20-AMEND-0005

Signature Point

Louisville Metro Development Review Committee

- **Modification of Binding Element.**

Fencing Exhibit

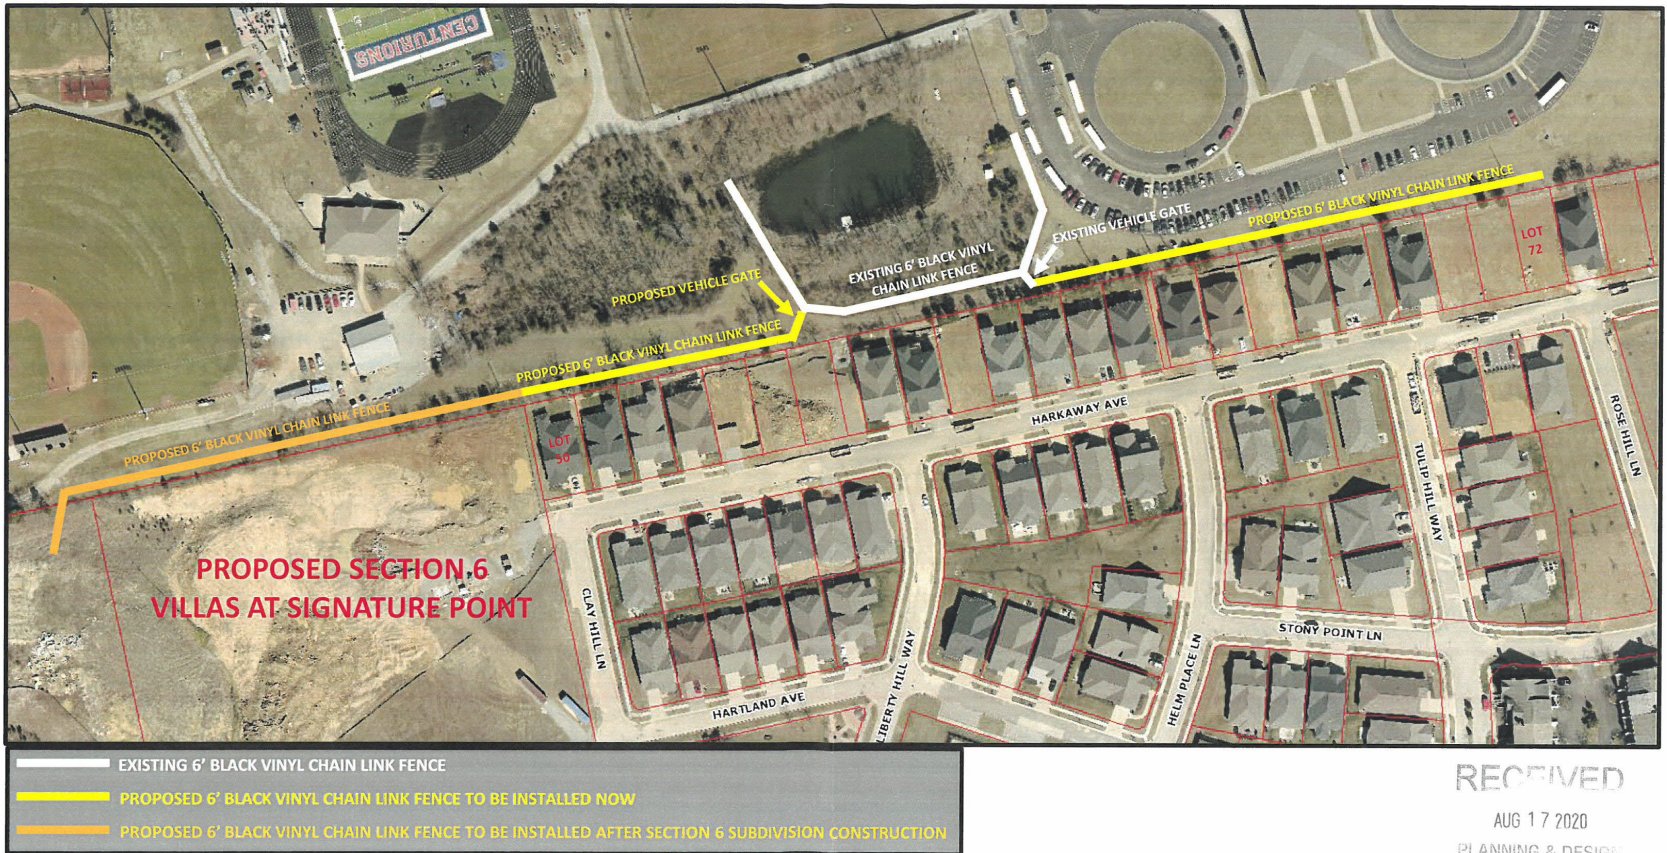
~~16. The developer shall, at its expense, construct a 7-foot chain link fence with black vinyl coating with a variety of deciduous and evergreen trees planted along this fence line on 10-foot centers along the entire property line common to Christian Academy of Louisville property. The fence shall be constructed at the earliest of the following times: (A) before construction begins on the buildings along the north line of the subject property; or (B) one year after site work begins anywhere on the subject property. The fence shall be perpetually maintained by the developer or its successor (Condominium Council, Homeowner Association, etc.).~~

The developer shall, at its expense, construct a 6-foot chain link fence with black vinyl coating as shown on the fencing exhibit presented at the September 16, 2020 Development Review Committee meeting.
